**Subject: NHTSA Campaign Number 13V-340/Jaguar Safety Recall J030 – XK Convertible Switch – Dealer Communications**

## **SUPPLEMENTARY INFORMATION**

**Publication Part No. JSA 18 02 30 991**

## Non-Compliance Recall J030 - Update

SJ1831

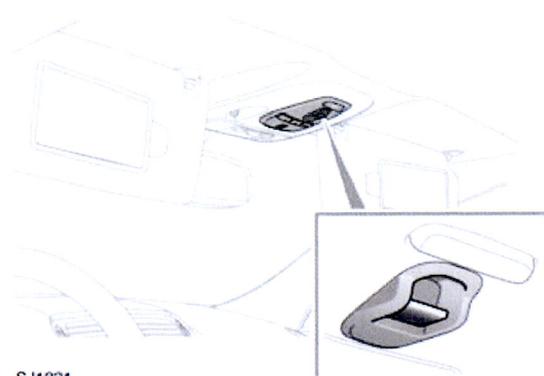
Rear quarter window switch (convertible only).

To operate the windows independently of the convertible roof when the convertible roof is closed:

- Press the convertible roof switch in the overhead console for less than a second and the rear quarter windows will fully open.
- Pull back on the switch and hold and the rear quarter windows will raise as long as the switch is held.

**Note:** When the convertible roof is opened, the rear quarter windows are automatically lowered and cannot be operated until the roof is closed. When the roof is closed, the rear quarter windows raise automatically.
